Project	IEEE 802.16 Broadband Wireless Access Working Group < http://ieee802.org/16 >	
Title	Structure and notation enhancements to IEEE P802.16h/D3	
Date Submitted	2007-11-13	
Source(s)	Paul Piggin NextWave Broadband Inc. 12670 High Bluff Drive San Diego CA 92130 USA	Voice: 1 858 480 3100 Fax: 1 858 480 3105 ppiggin @ nextwave.com
Re:	Letter Ballot #29 of IEEE P802.16h/D3.	
Abstract	There are a number of structural and notional enhancements that should be applied to the IEEE P802.16h/D3 draft.	
Purpose	Ensuring the readability of the draft IEEE P802.16h/D3.	
Notice	<i>This document does not represent the agreed views of the IEEE 802.16 Working Group or any of its subgroups. It represents only the views of the participants listed in the "Source(s)" field above. It is offered as a basis for discussion. It is not binding on the contributor(s), who reserve(s) the right to add, amend or withdraw material contained herein.</i>

Structure and notation enhancements to IEEE P802.16h/D3

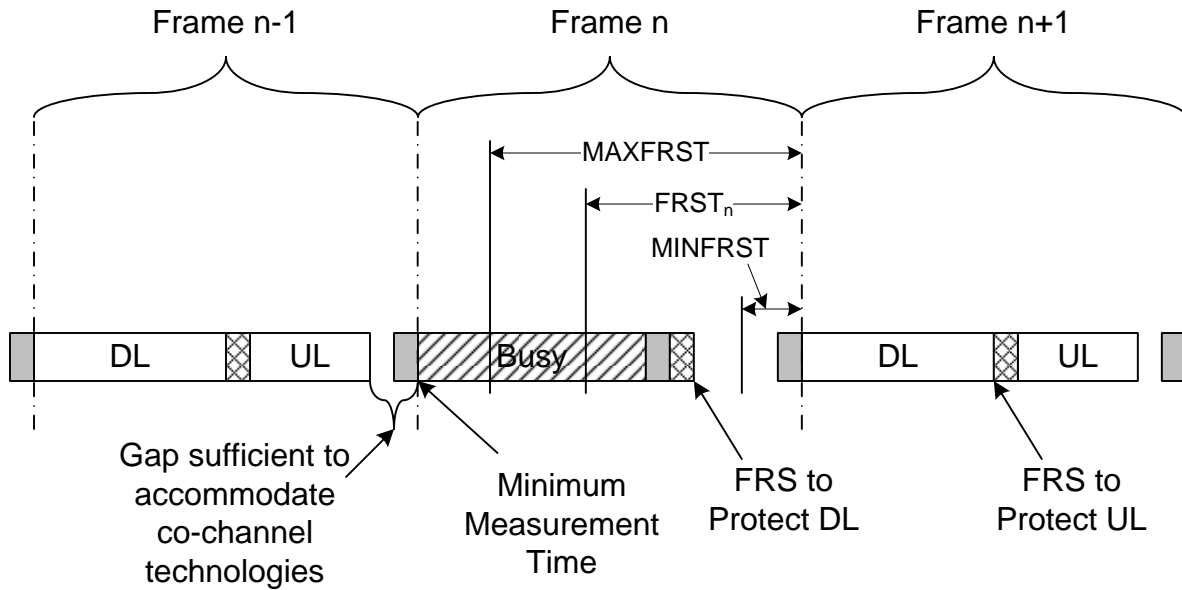
Replace the first paragraph at the beginning of 6.4.2.3.4 [1], page 33, line 39 with the following.

Co-channel coexistence between multiple 802.16 systems is achievable by the sharing of frames whereby advantage is derived from the synchronous behavior of 802.16. This sharing is reliant upon a known frame allocation and network synchronization. The mechanism for co-channel coexistence at the frame level is related to the band of operation, but all BS must be synchronized to GPS or NTP if GPS is not available. Situations exist where frames may be assigned to 802.16 systems by administrative means. This administrative provisioning eliminates the need to support a discovery protocol, and an a priori knowledge of frame allocation patterns. Such situations occur, for example, in bands where a regulatory requirement demands device registration together with information on device location. It is therefore possible to make use of this location information and make informed decisions on which systems should be assigned to which frames. Administrative provisioning shall therefore be used if sufficient information is available, otherwise a discovery protocol or standardized frame structure shall be used.

For the case of administrative provisioning and coexistence with asynchronous non-802.16 systems, 802.16 systems operating in a particular geographical area shall share all frames among all the 802.16 systems. The final decision to use a particular frame or not is based on channel measurements and ongoing fair sharing requirements as described in subclause 6.4.2.3.7. The remainder of this subclause describes the case where administrative provisioning is not possible. This scenario allows sharing in time of the channel by up to three different uncoordinated 802.16 systems using a four frame sequence.

Figure h19—Reclaiming the Medium Timing parameters of the DMA algorithm

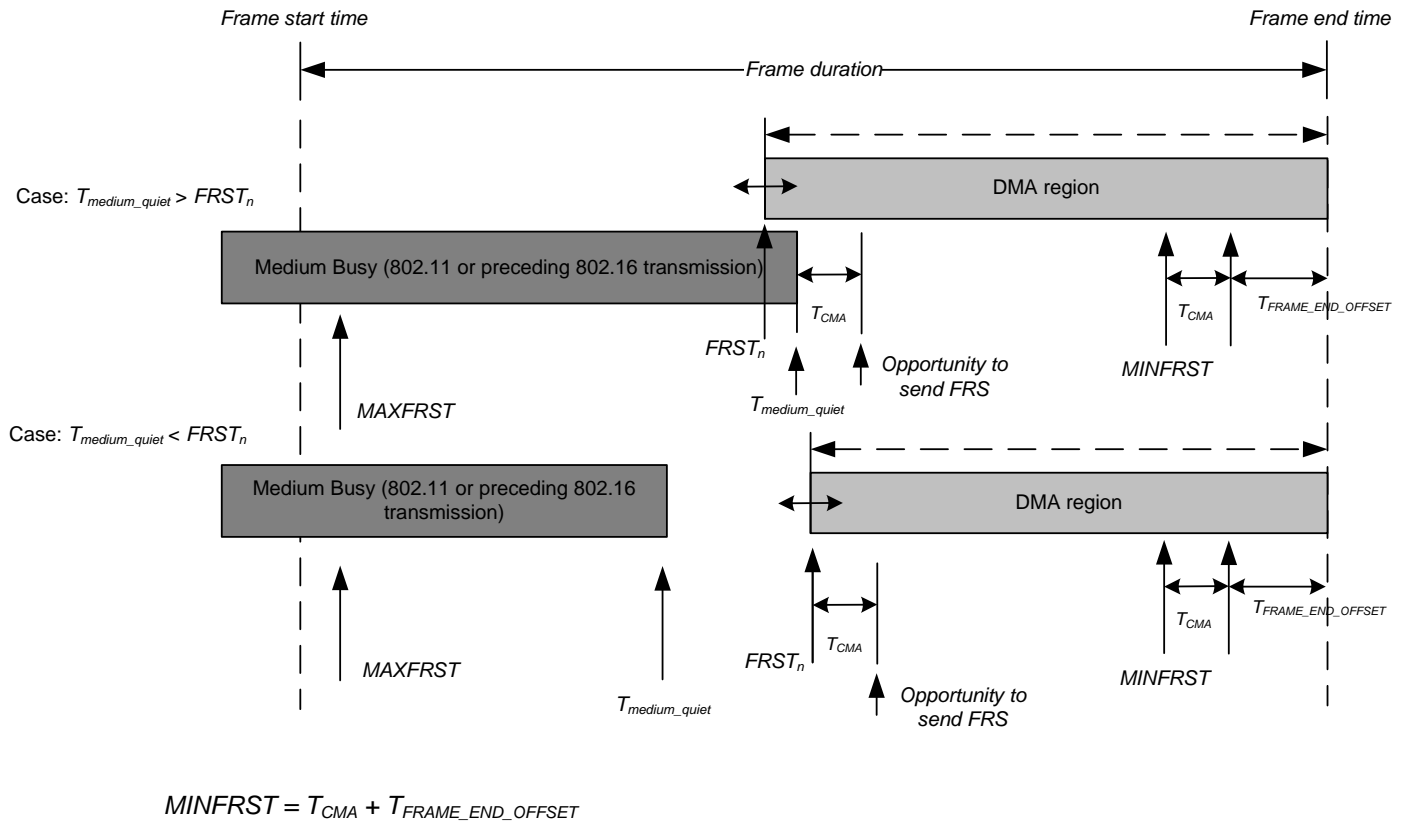
The relationship between frames boundaries and the DMA algorithm is shown in [Figure h x1x](#); The DMA algorithm timing parameters are applied as shown in [Figure h 19](#).

Replace [Figure h19](#) in [1] 'Reclaiming the Medium' with the following. Also make the caption changes as shown.

Figure h21 (a) Downlink FRS

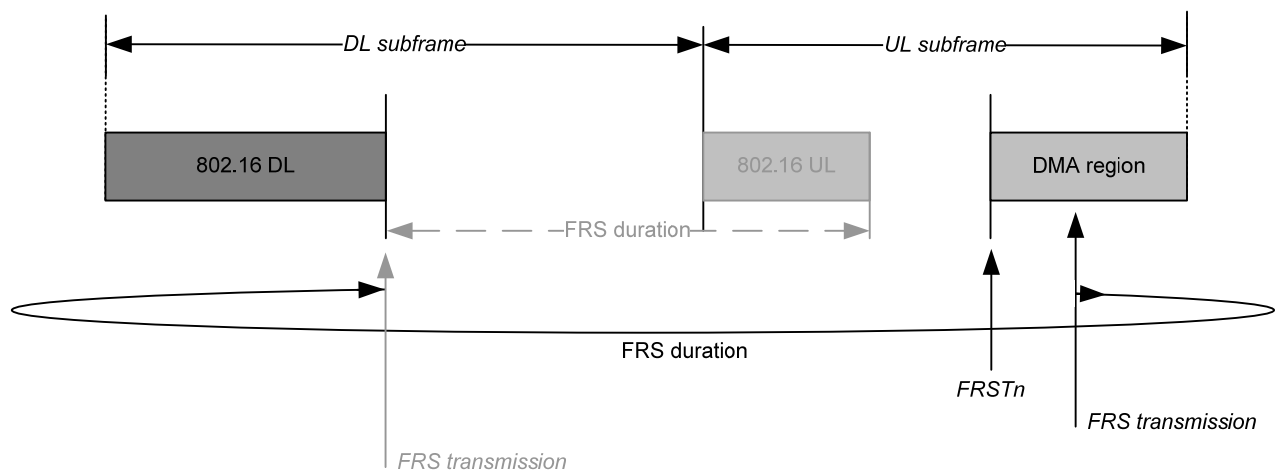
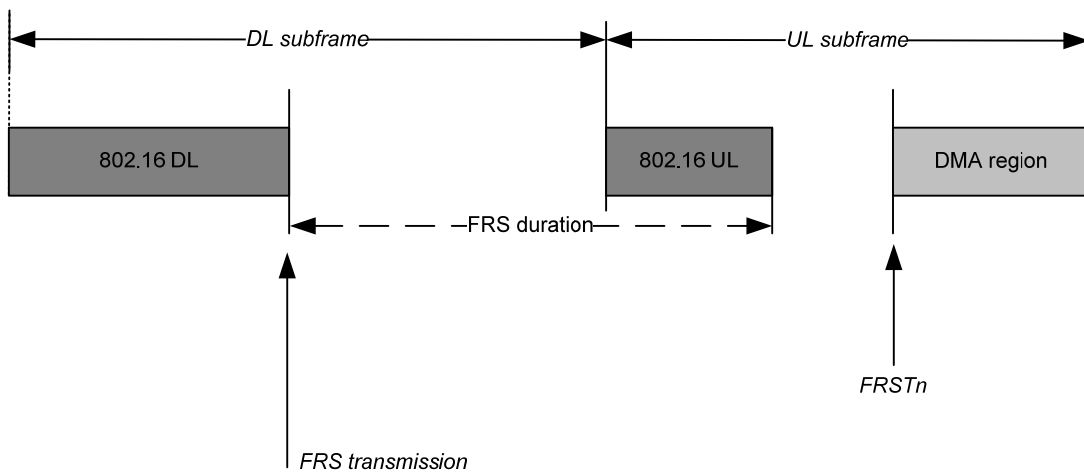
When using any carrier sense protocol, such as LBT, in a wireless environment the hidden node problem cannot be 100% avoided. It can only be mitigated. Additionally, in bands such as 3.65 GHz in the US, there is an aggravated hidden node problem due to the distinctly lower transmit power allowed for mobile devices compared to fixed, registered devices. The mobiles are more often geographically disadvantaged due to this transmit power disparity. Fixed, registered client devices can also be geographically disadvantaged (the classical hidden node problem), although not as often. To remedy this the BS transmits a Frame Reservation Signal (FRS) at the end of the DL subframe to reserve the subsequent UL subframe (or used portion, thereof) for the subscriber stations. The BS also transmits an FRS in the DMA region at the time a decision is made to claim the medium. The form of the FRS is band dependent and should be structured to be receivable by other technologies that may be co-channel. For instance, in bands where 802.11 would be a typical co-channel asynchronous system, the 802.11 CTS transmitted using the appropriate 802.11 burst structure would suffice. The reservation of the DL and UL subframe by the BTS precludes the need for the SS to also perform LBT. ~~The use of~~ An example of using the FRS to protect the DL and UL is shown in Figure h 21.

Replace figure h21 with the following.
